FINAL PLAT
HIDDEN ESTATES ADDITION
AN ADDITION TO SEDGWICK COUNTY, KANSAS

RE: SUB 2002-58 -- One-Step Final Plat of Hidden Estates Addition

CASE NUMBER: SUB 2002-58 -- HIDDEN ESTATES ADDITION

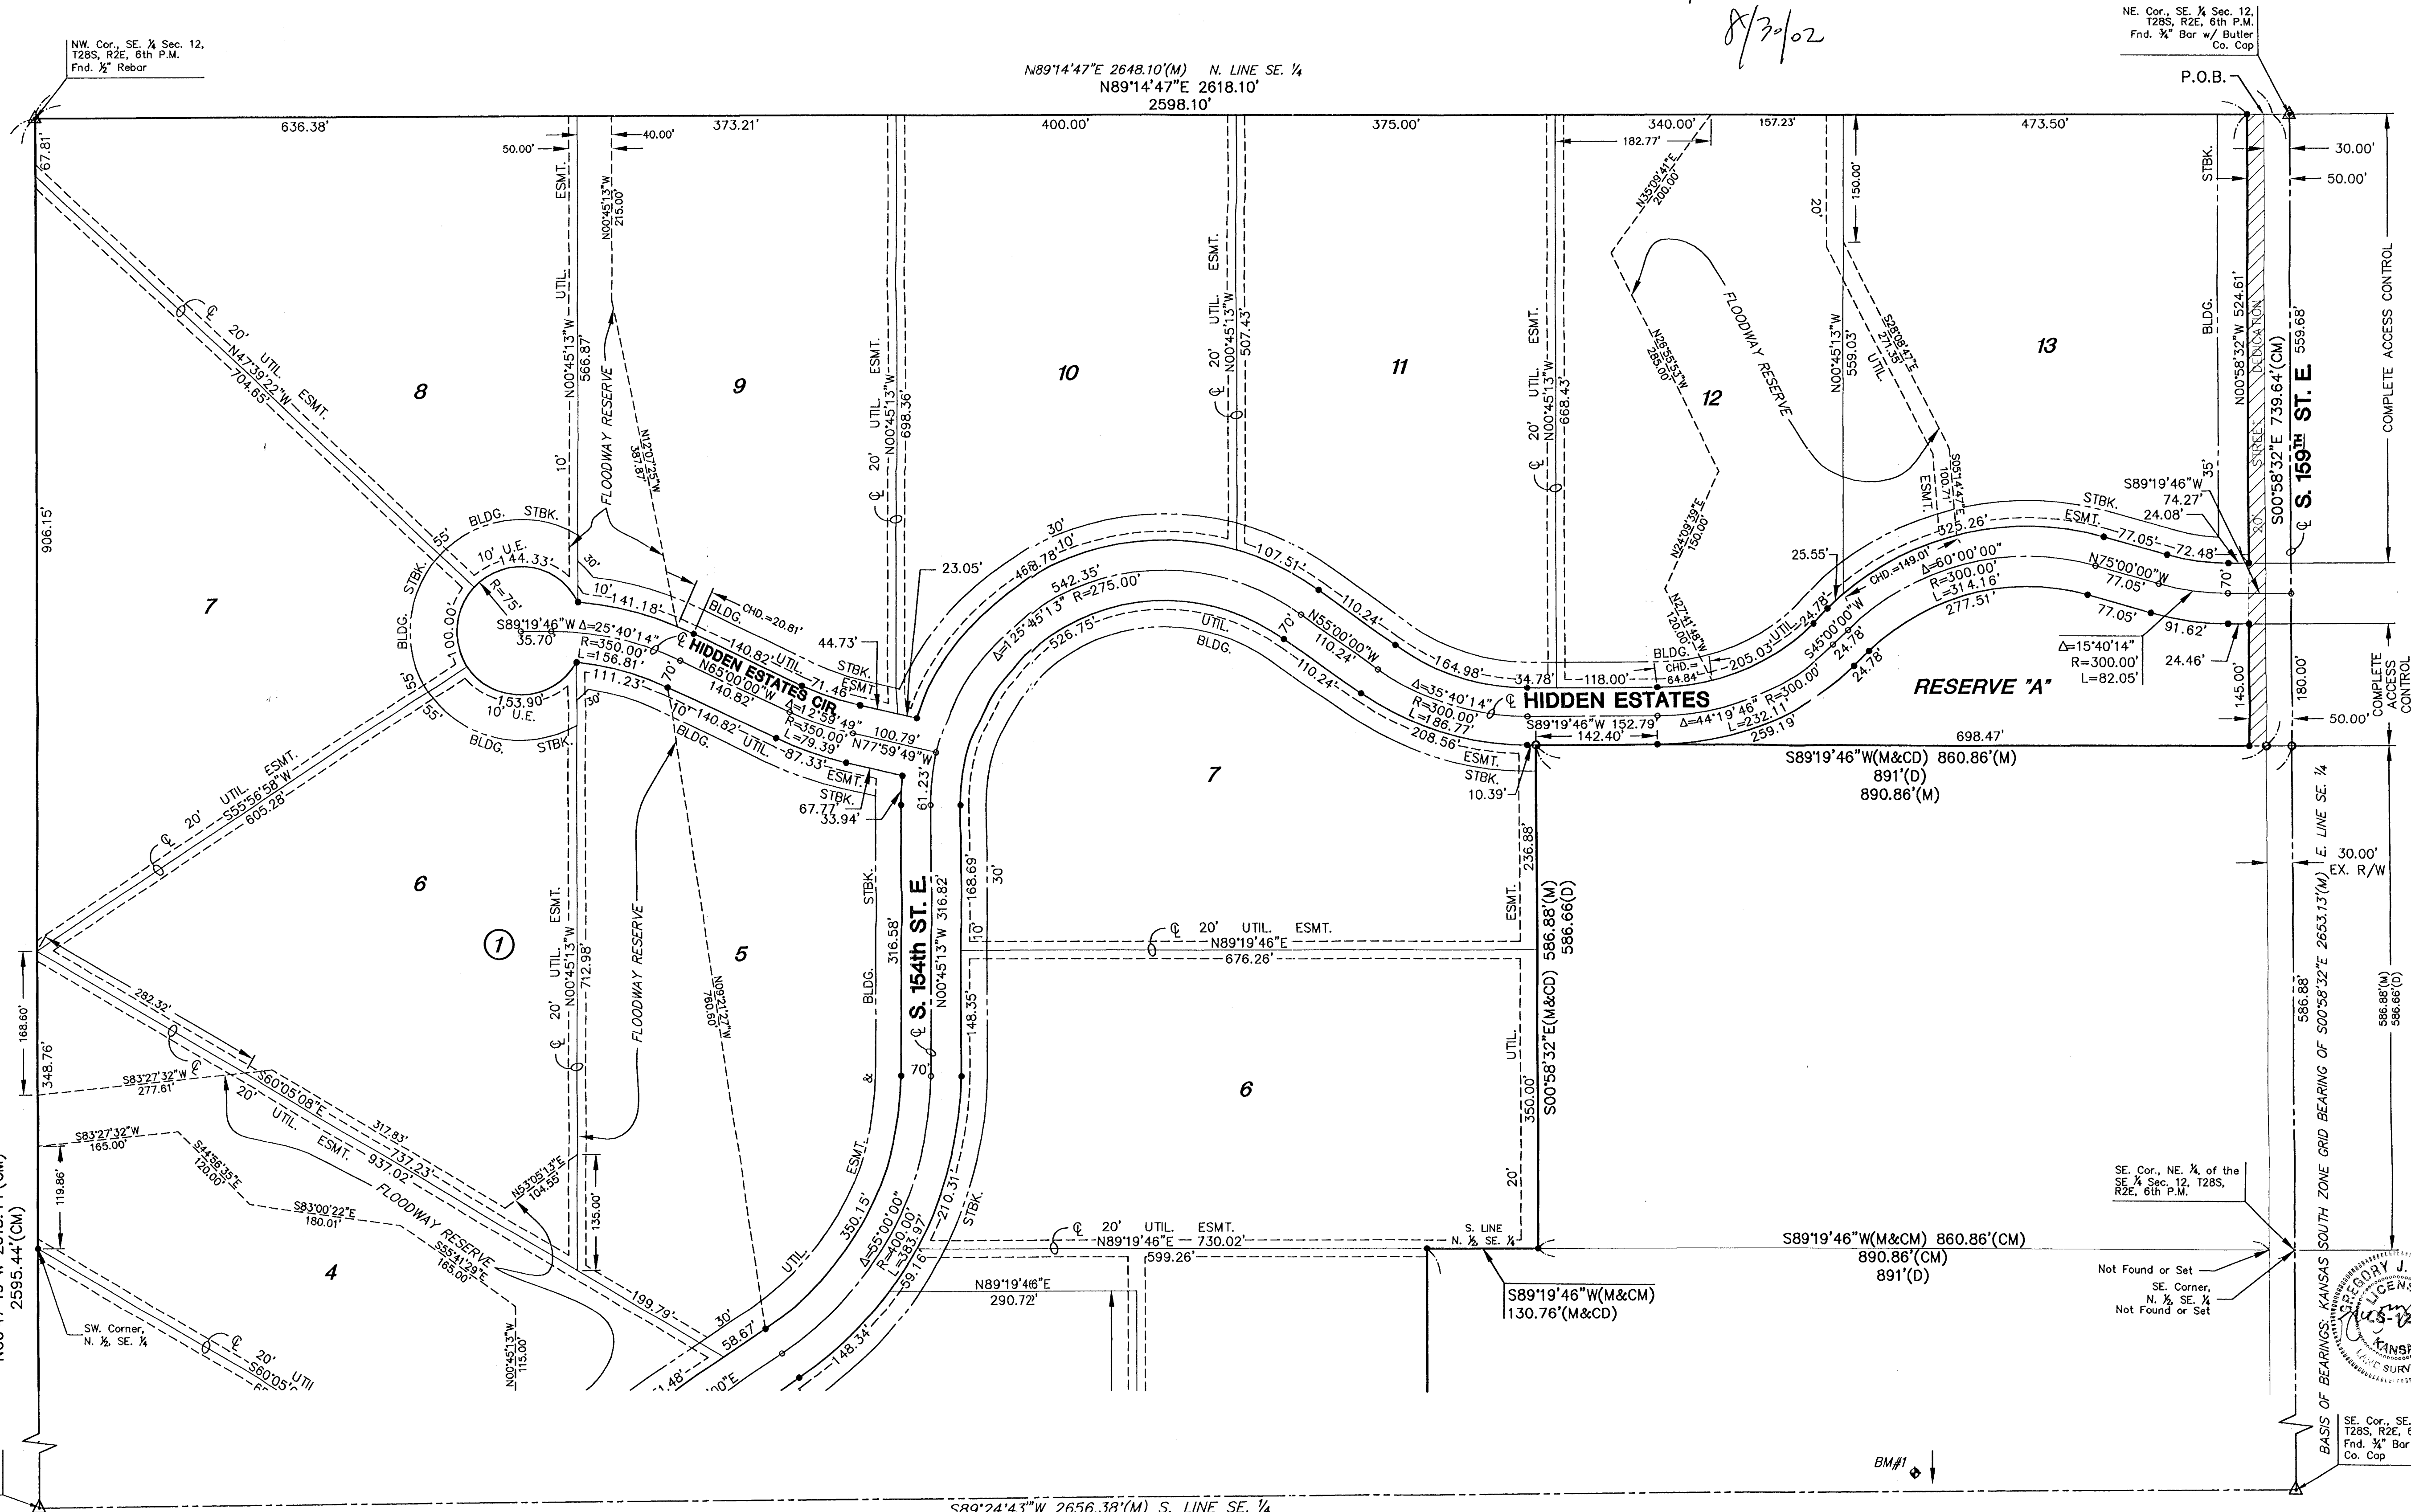
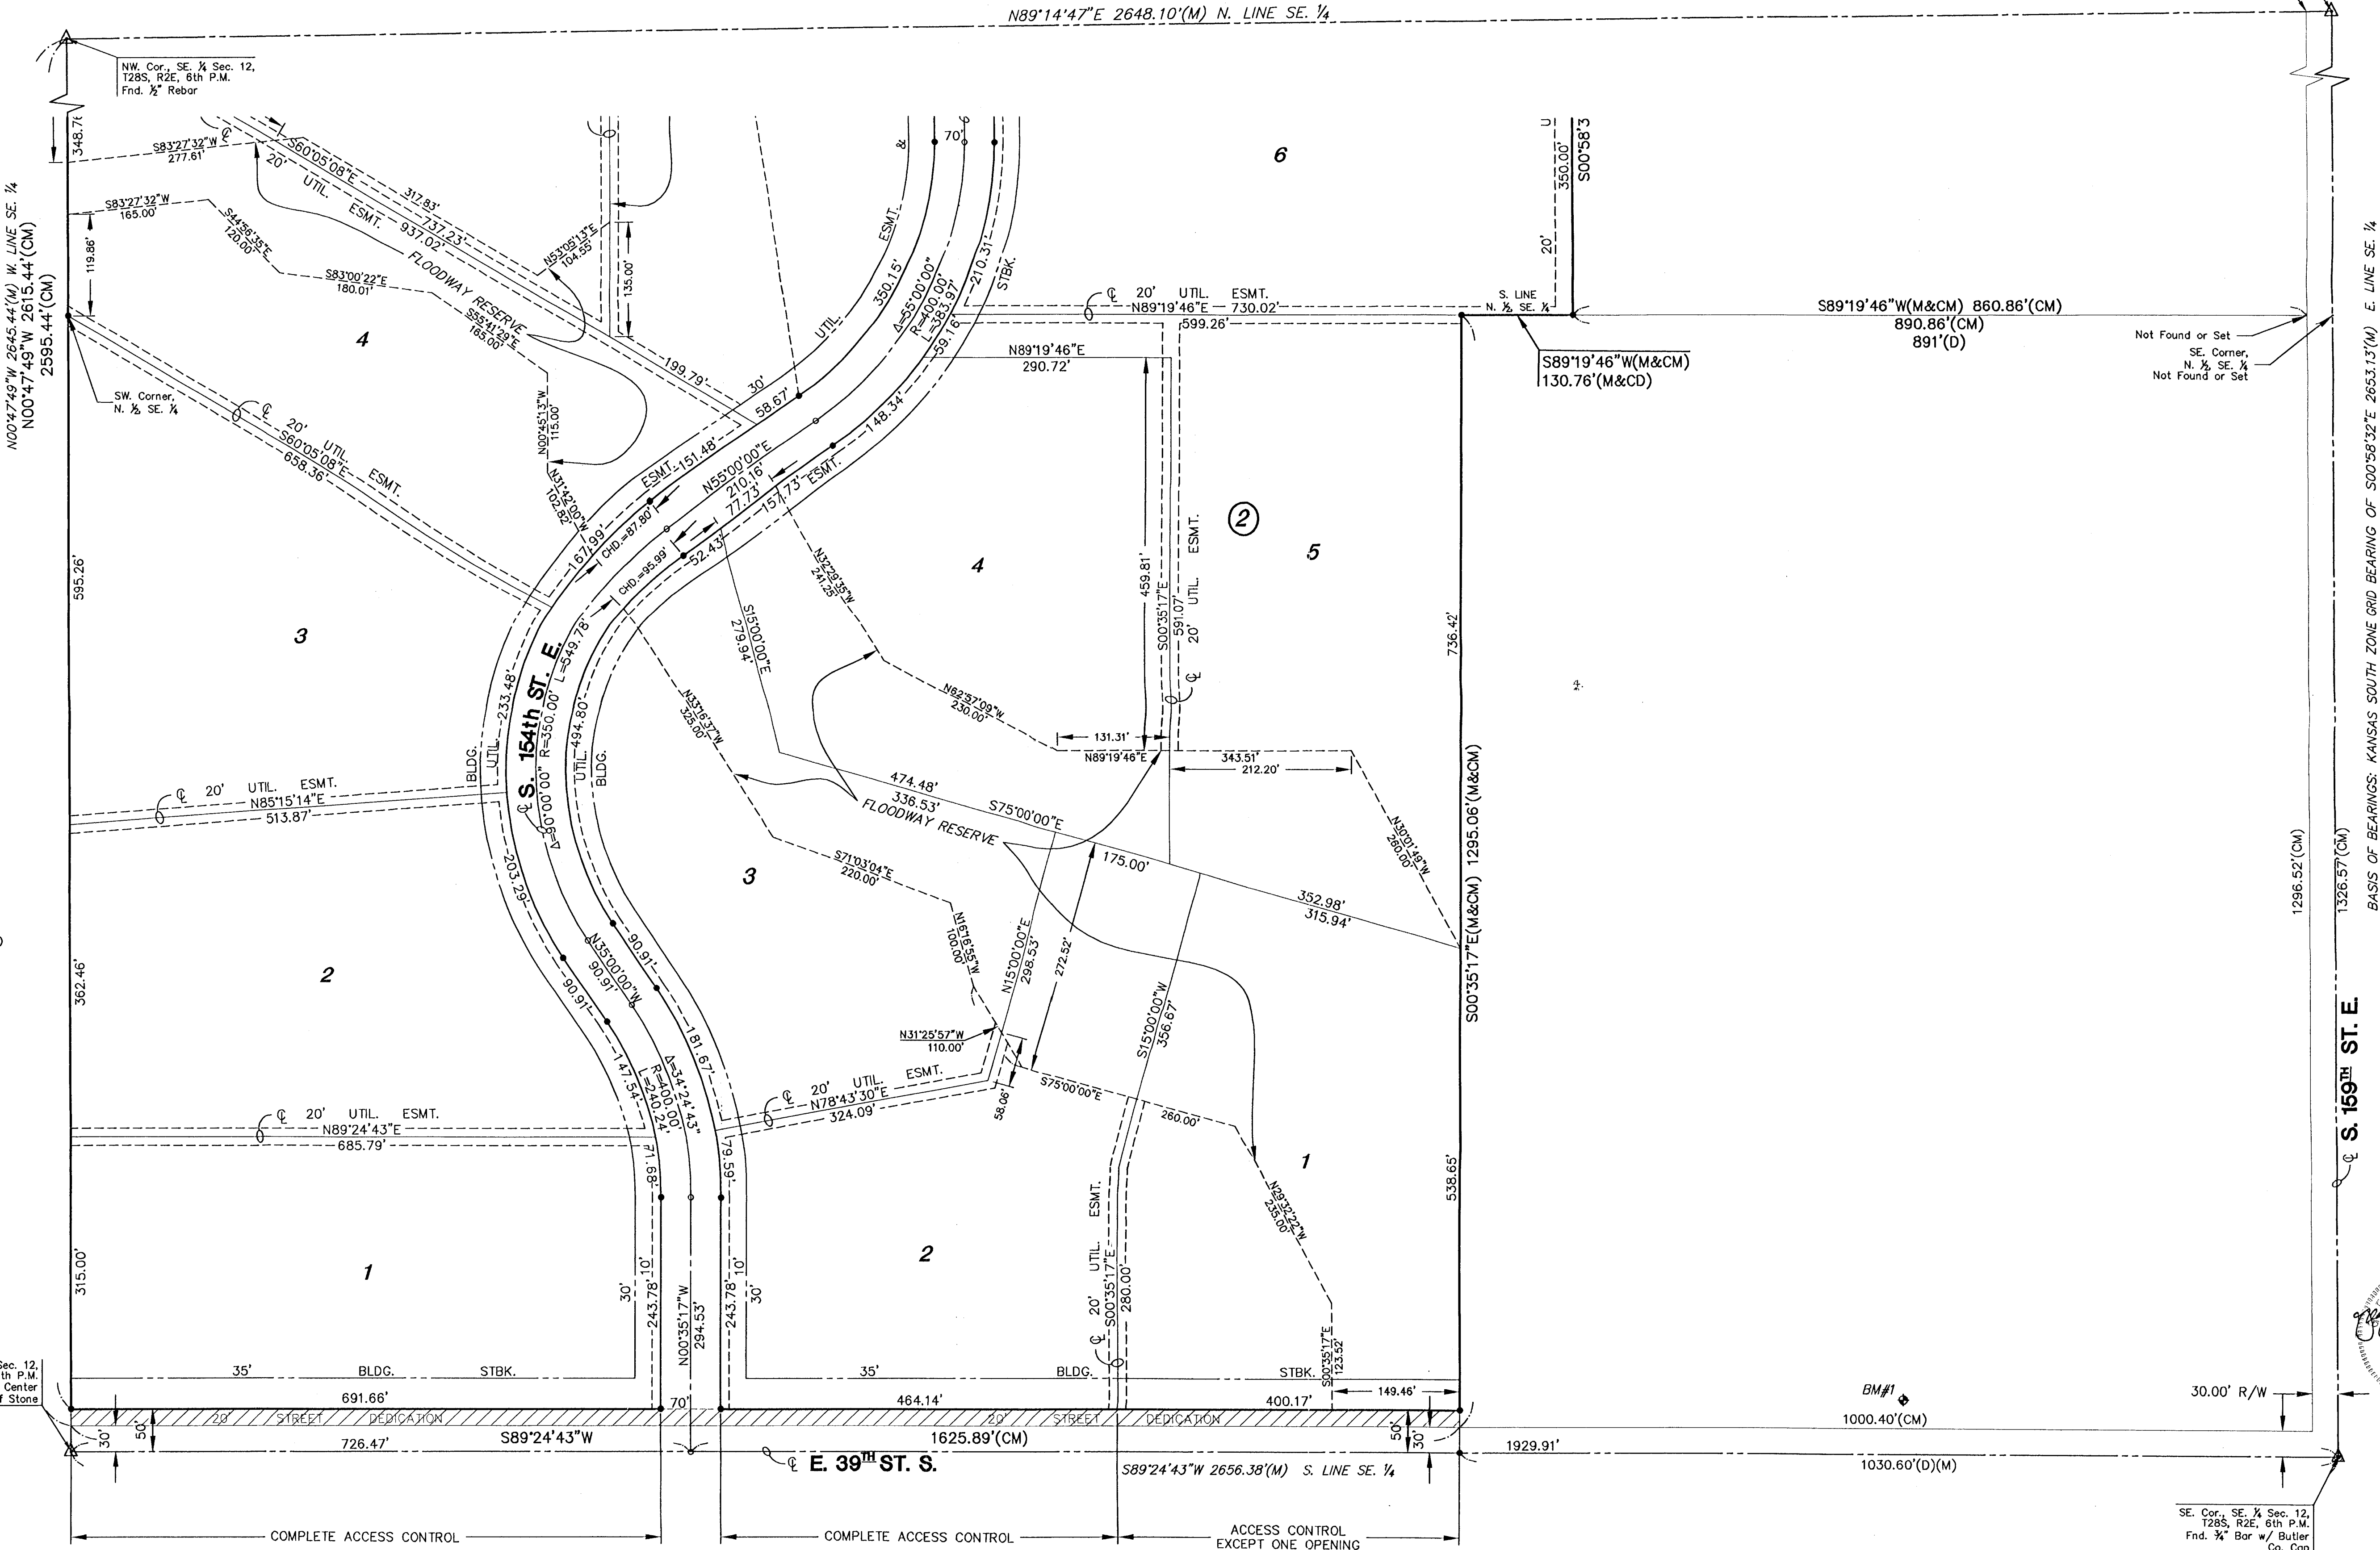
- D. **County Engineering** needs to comment on the status of the applicant's drainage plan. **Drainage easements need to be located in floodway reserves. The standard floodway language needs to be included in the plat's text.**

- E. **County Engineering** needs to comment on the access controls. Complete access control has been platted along the plat's frontage to perimeter streets. Lot 1, Block 2 has been platted with no access. **County Engineering has recommended access on the west side of Lot 1, Block 2.**

- F. **The Subdivision Committee has requested utility easements between the lots.**
- G. **County Surveyor** has advised that all deltas need the "?" changed.

- H. **County Surveyor** has advised that Lot 5, Block 2 needs a dimension at the northwest corner.
- I. **County Engineering** has required that the street layout be reconfigured to connect to the street to the north. **MAPD** requests a street connection to the west. **Due to drainage constraints, these conditions were not approved by the Subdivision Committee.**

- N. The right-of-way widths should be denoted for the internal streets.
- O. The cul-de-sac bulb needs to be increased to a 75 feet radius.
- P. Provisions shall be made for ownership and maintenance of the proposed reserves. The applicant shall either form a lot owners' association prior to recording the plat or shall submit a covenant stating when the association will be formed, when the reserves will be deeded to the association and who is to own and maintain the reserves prior to the association taking over those responsibilities.

- T. Lots 6, 7, and 8, Block 1 do not conform with the 200-ft lot width standard which is measured at the building setback line. An increase in the distance of the building setback from the road would meet the standard. *The lot widths will be revised upon increase of the cul-de-sac bulb diameter.*

- U. Lot 7, Block 1 does not meet the 100-ft lot frontage requirement. *The frontage will be revised upon increase of the cul-de-sac bulb diameter.*
- V. Approval of this plat will require a waiver of the lot depth to width ratio of the Subdivision Regulations for Lots 6, 7, and 8, Block 1. The Subdivision Regulations state that the maximum depth of all residential lots shall not exceed 2.5 times the width. *The lot depth to width ratio will be revised upon increase of the cul-de-sac bulb diameter.*

- W. The County Fire Department/GIS needs to comment on the plat's street names. *Arterial street names need to be corrected on the face of the plat and in the plat's text. The east/west Hidden Estates Parkway should be revised to Hidden Estates. The north/south Hidden Estates should be revised to "S. 154th St. E."*
